Working Party on Lighting and Light-Signalling

Seventy-first session

Proposal for Supplement 26 to the 01 Series of Regulation No. 6

**Submitted by the expert from the International Automotive Lighting
and Light Signalling Expert Group***

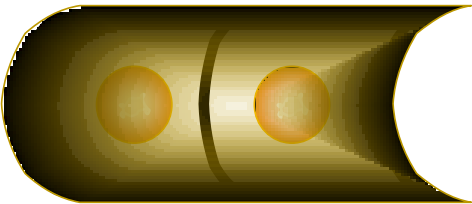
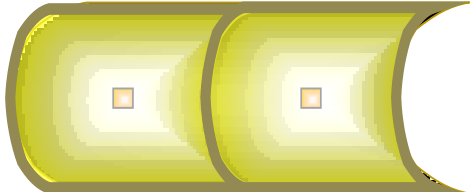
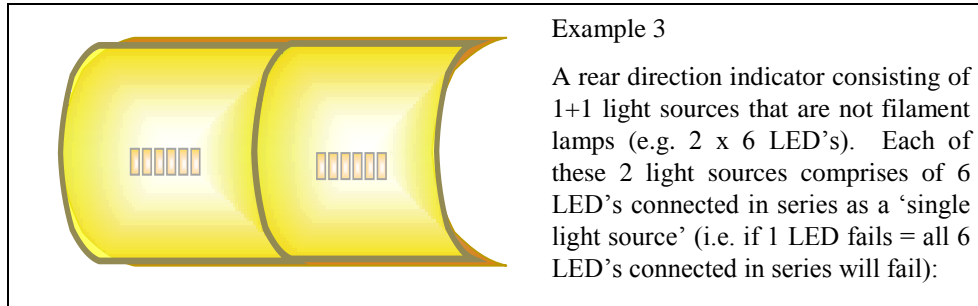
<p>Example 1</p> <p>A rear direction indicator consisting of 1+1 filament light sources (e.g. 2 x 1 PY21W) according to the existing wording of UN Regulation No.6 paragraph 6.2.2 (b)</p>
	<p>Example 2</p> <p>A rear direction indicator consisting of 1+1 light sources that are not filament lamps (e.g. 2 x 1 LED):</p>

Example 3

A rear direction indicator consisting of 1+1 light sources that are not filament lamps (e.g. 2 x 6 LED's). Each of these 2 light sources comprises of 6 LED's connected in series as a 'single light source' (i.e. if 1 LED fails = all 6 LED's connected in series will fail):

These three examples show rear direction indicator lamps comprising different light source arrangements representing the same basic lighting performance concept, i.e.:

Example 1: 2 filament bulbs = 2 light sources

Example 2: 2 LED's = 2 light sources

Example 3: 2 groups of LED's, each one arranged as a "single light source" = 2 light sources
